APPROVED MINUTES

November 18, 2010 Standards Committee Meeting

RE: Minutes for the November 18, 2010 Standards Committee Meeting

PROPOSED REVISION TO 701-BPIL-06 ALTERNATE STEEL H-PILE SPLICE (REVISED, SEE COMMENTS AND ACTION)

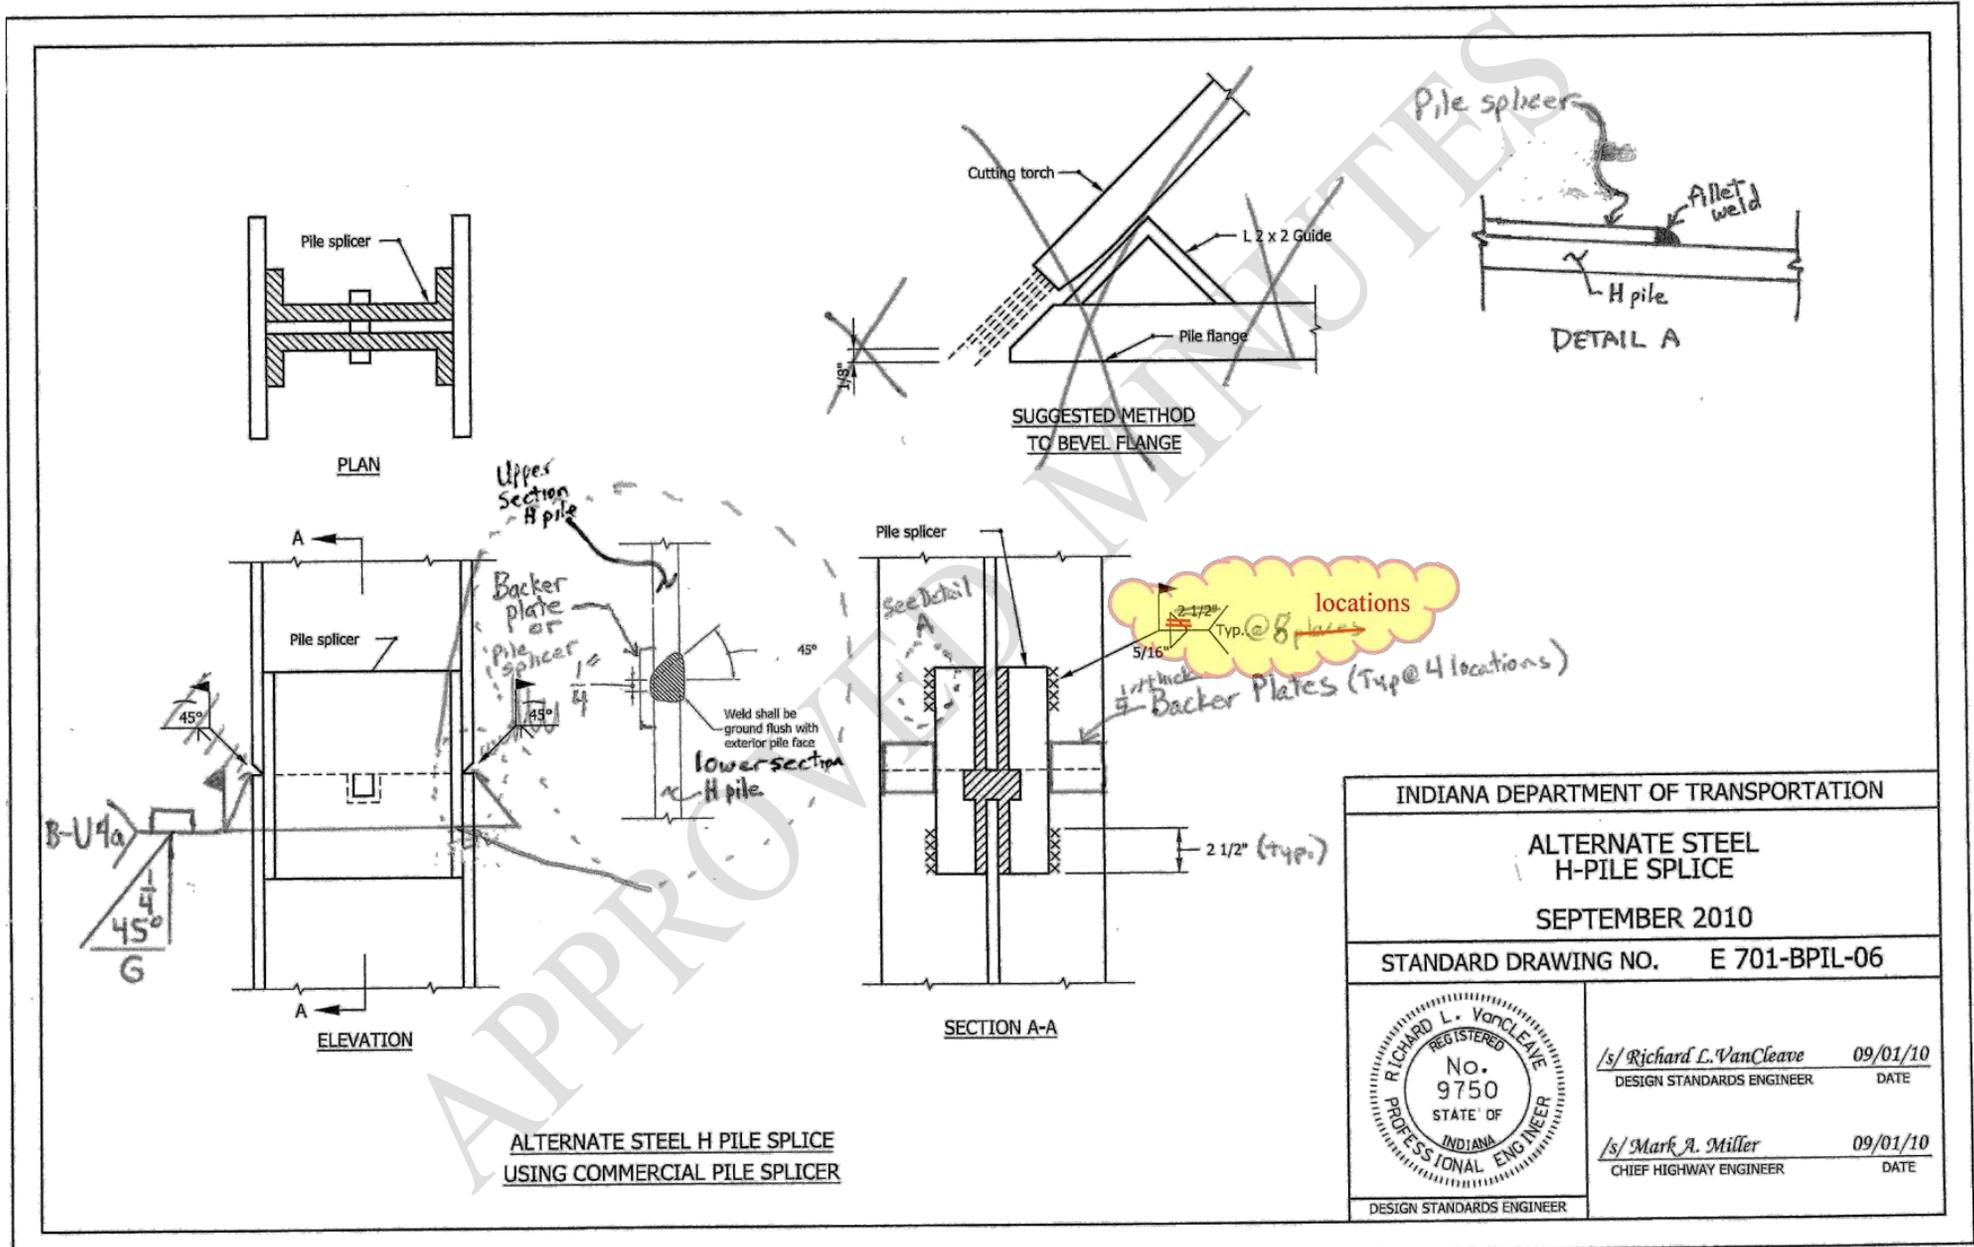
Mr. Reilman explained the changes they are proposing to the standard drawings shown on page 10 and 11 of the meeting agenda.

Mr. Strain inquired about the best way to illustrate the welds shown to make sure they match AWS code. Mr. Reilman said he will look into them and verify they are accurate and illustrated correctly.

All agreed that the proposed changes will go into the 2012 book as amended. Proposed Revised Draft drawings are included in these minutes. Changes are shown as highlighted in yellow.

BACKUP NO.1 EXISTING 701-BPIL-05 STEEL H-PILE SPLICE PROCEDURE. (PROPOSED TO BE REPLACED).

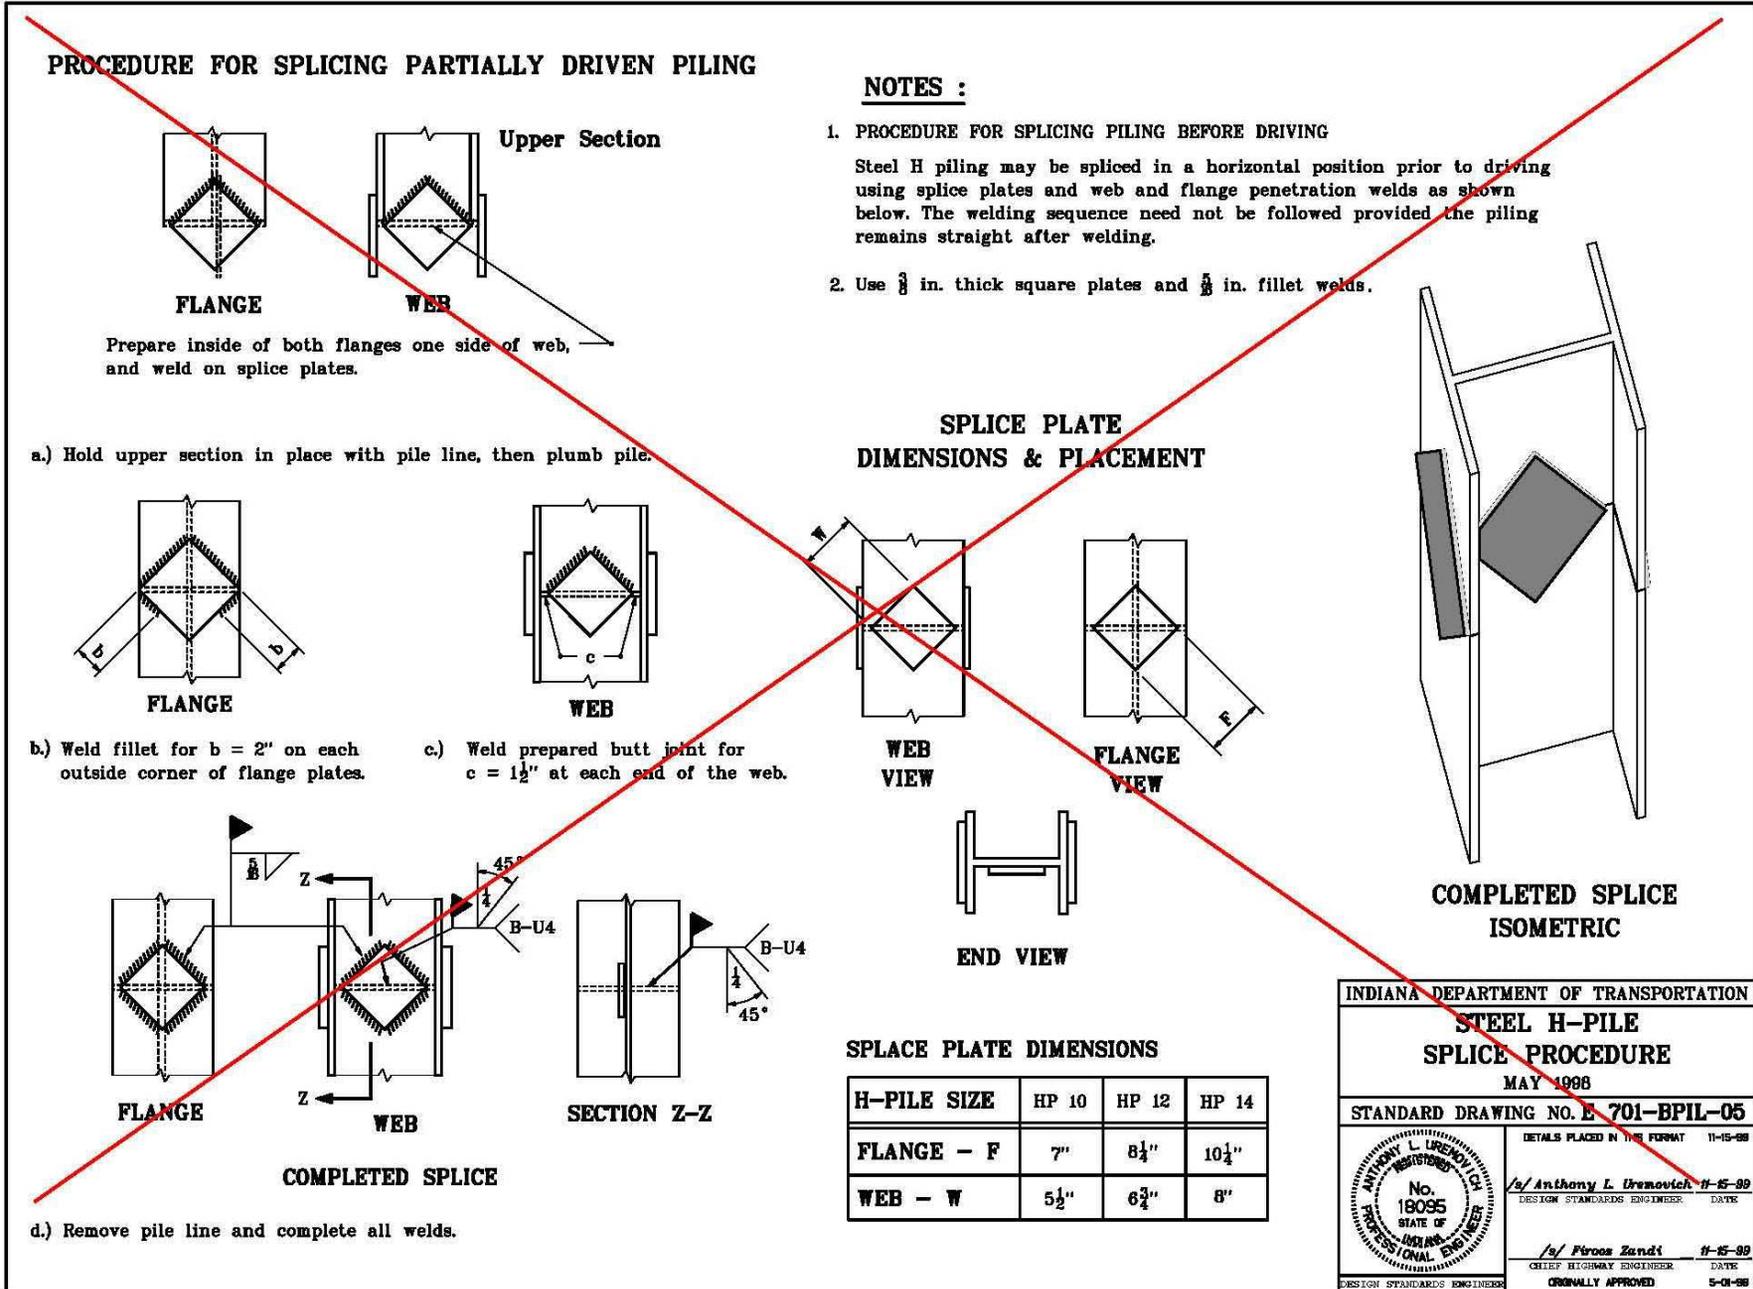
PROPOSED SOLUTION: Modify standard drawings 701-BPIL-04, delete the existing standard drawing 701-BPIL-05 and replace it with a new drawing, and modify 701-BPIL-06. Also incorporate minimum preheat language into 701.11.

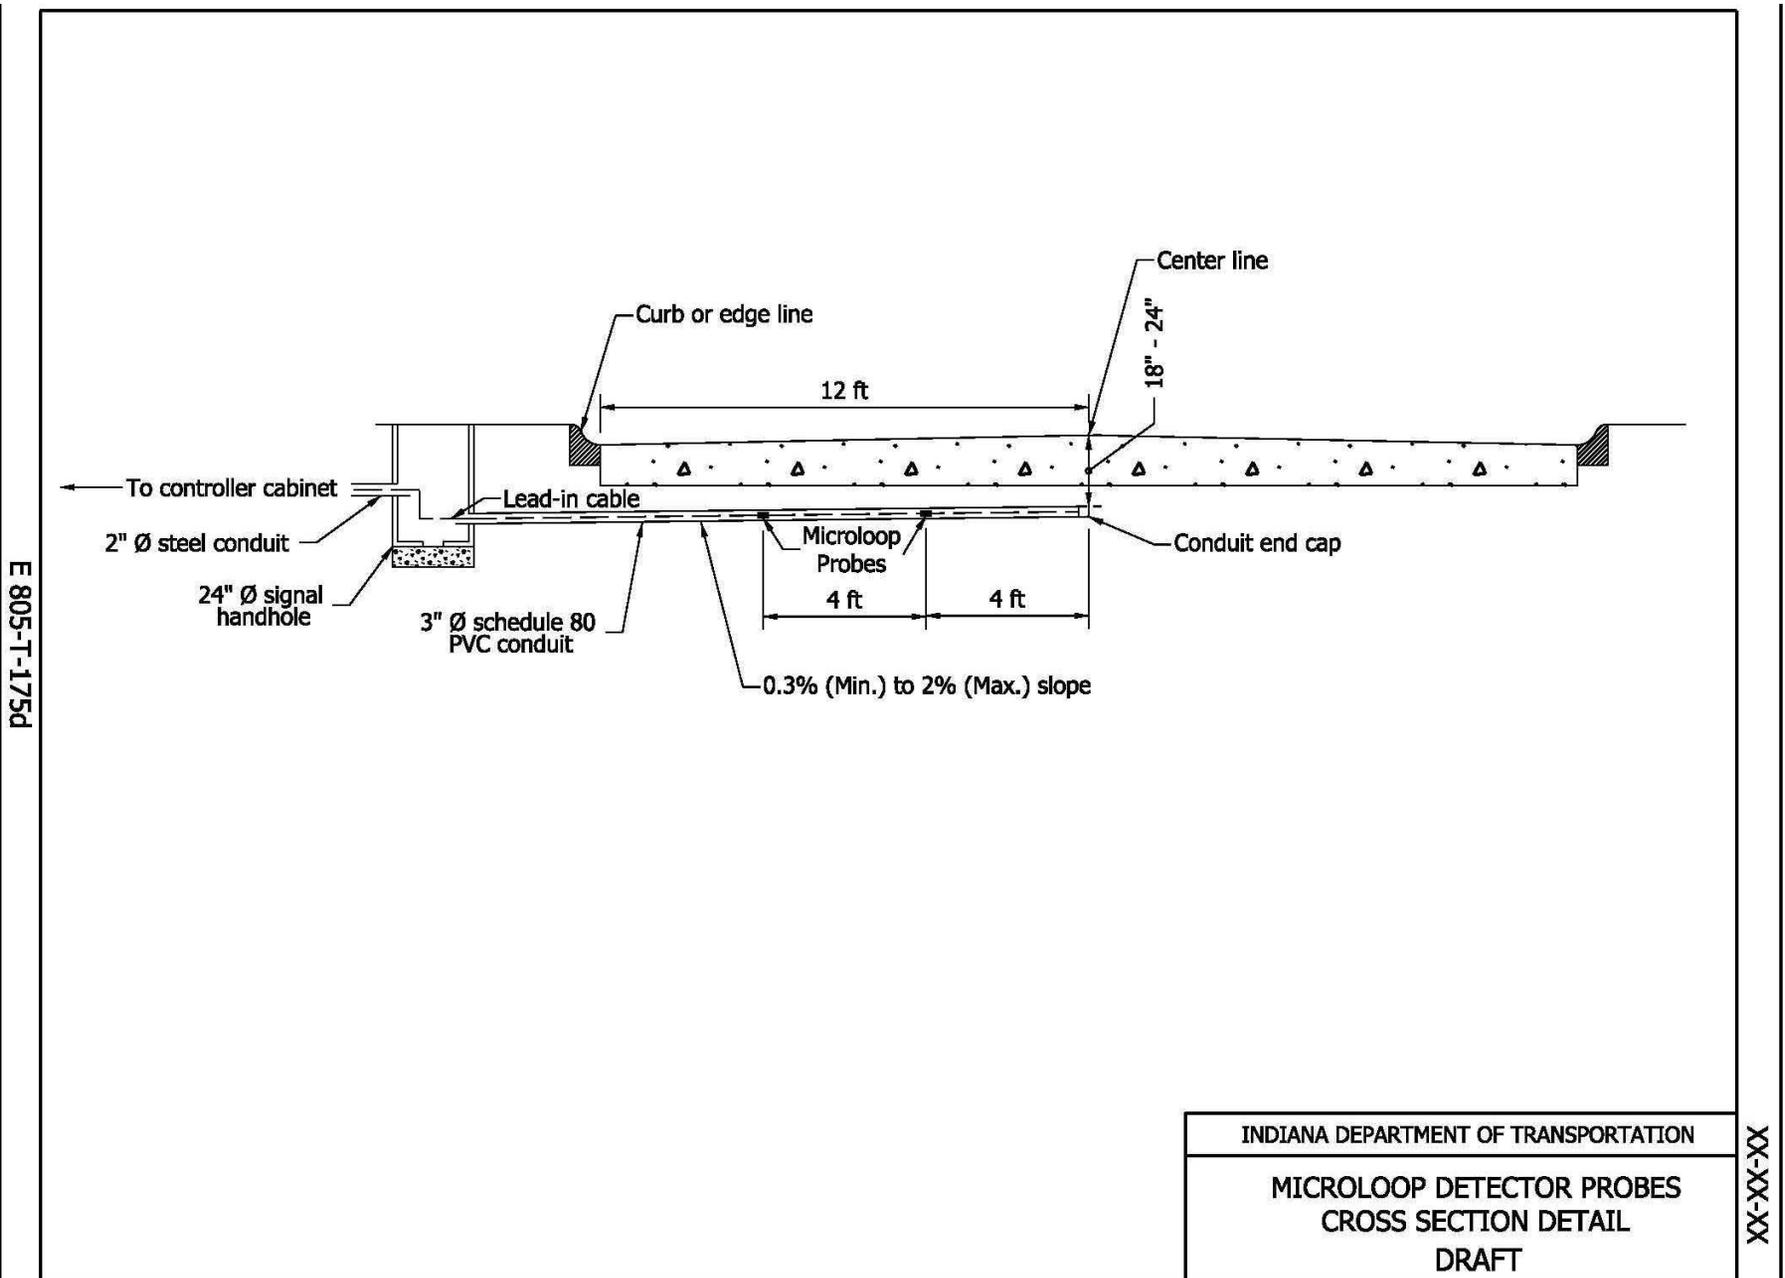
Mr. Caplinger asked about the depth of the conduit since it is inserted under the existing pavement. Mr. Andrews said it is usually bored and recommended adding language covering damaged pavement during installation.
